TRANS/WP.29/2002/9
18 December 2001

PROPOSAL FOR DRAFT SUPPLEMENT 22 TO THE 03 SERIES OF AMENDMENTS
TO REGULATION No. 37

(Filament lamps)

Transmitted by the Working Party on Lighting and Light-Signalling (GRE)

Figure 1 - Main drawing

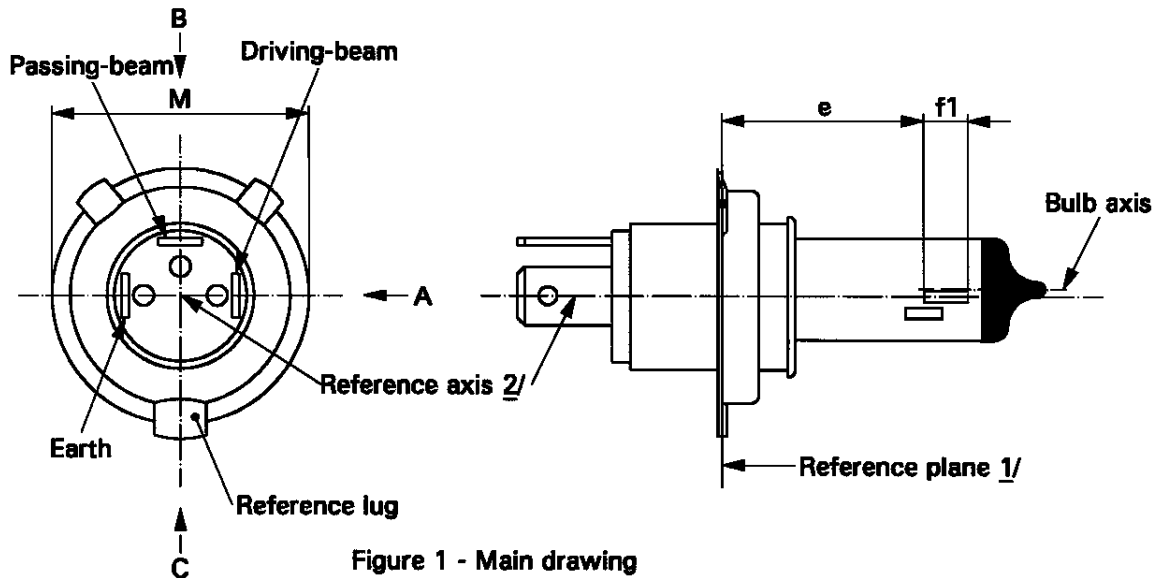
Add at the end new data sheets H14/1 to H14/4, to read:

- 1/ The reference plane is defined by the points on the surface of the holder on which the three lugs of the cap ring will rest.
- 2/ The reference axis is perpendicular to the reference plane and passing through the center of the cap ring diameter 'M'.
- 3/ Glass bulb and supports shall not exceed the envelope as indicated in figure 2. The envelope is concentric to the reference axis.

View B Figure 3 - Distortion free area 4/ and black top 5/

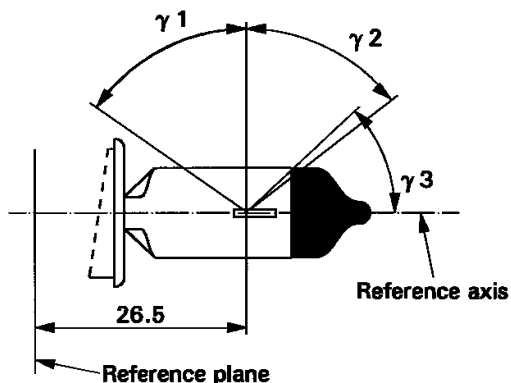
- 4/ Glass bulb shall be optically distortion free within the angles γ_1 and γ_2 . This requirement applies to the whole bulb circumference within the angles γ_1 and γ_2 .

- 5/ The obscuration shall extend at least to angle γ_3 and shall extend at least to the cylindrical part of the bulb on the whole bulb top circumference.

View A Figure 4 - Bulb eccentricity 6/

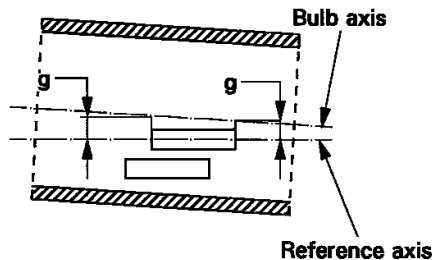
- 6/ Eccentricity of bulb with respect to passing-beam filament axis is measured in two planes parallel to the reference plane where the projection of the outside of the end turns nearest to or furthest from the reference plane crosses the passing-beam filament axis.

View A View B,C Figure 5- Offset of filament axis 7/ (for standard filament lamps only)

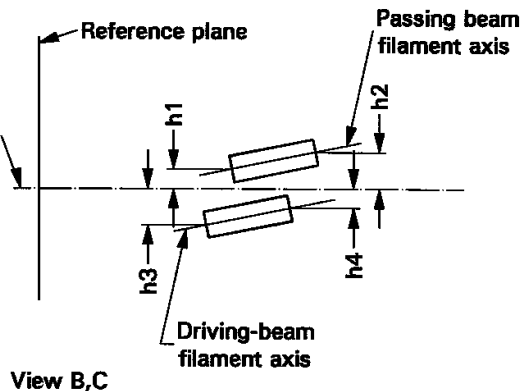
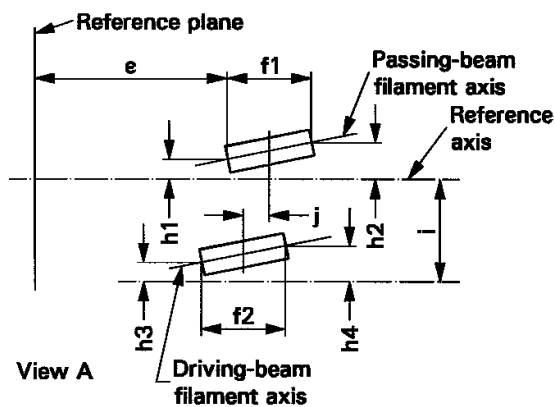
- 7/ The offset of the filaments with respect to the reference axis is measured only in viewing direction A, B and C as shown in figure 1 on sheet H14/1. The points to be measured are those where the projection of the outside of the end turns nearest to or furthest from the reference plane crosses the filaments axis.

Sheet H14/3

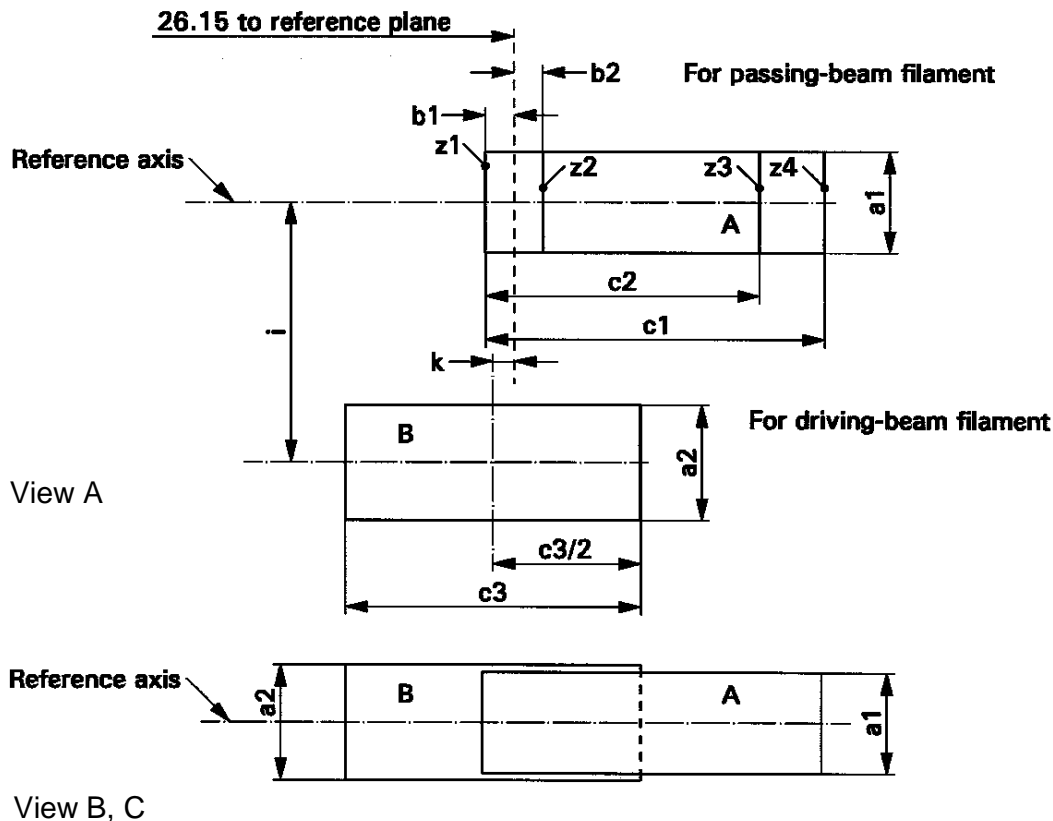
Dimensions in mm		Filament lamp of normal production		Standard filament lamps	
e	<u>8/</u>	26.15	<u>12/</u>	± 0.1	
f1	<u>8/ 9/</u>	5.3	<u>12/</u>	± 0.1	
f2	<u>8/ 9/</u>	5.0	<u>12/</u>	± 0.1	
g		0.3 min.			
h1		0	<u>12/</u>	± 0.1	
h2		0	<u>12/</u>	± 0.15	
h3		0	<u>12/</u>	± 0.15	
h4		0	<u>12/</u>	± 0.15	
i		2.7		-	
j		2.5	<u>12/</u>	± 0.1	
γ1		55° min.	-	-	
γ2		52° min.	-	-	
γ3		43°	0/-5°	0/5°	
Cap P38t-33 in accordance with IEC Publication 60061 (sheet 7004-....-1)					
ELECTRICAL AND PHOTOMETRIC CHARACTERISTICS					
Rated values	Volts	12		12	
	Watts	55	60	55	60
Test voltage	Volts	13.2		13.2	
Objective values	Watts	68 max.	75 max.	68 max.	75 max.
	Luminous flux	1150 ± 15%	1750 ± 15%		
Reference luminous flux at approximately. 12 V				860	1300

8/ The ends of the filaments are defined as the points where, when the viewing direction is direction A as shown in figure 1 on sheet H14/1, the projection of the outside of the end turns crosses the filaments axis.

9/ "f1" represents the length of the passing-beam filament and "f2" represents the length of the driving-beam filament.

10/ "d1" represents the diameter of the passing-beam filament and "d2" represents the diameter of the driving-beam filament.
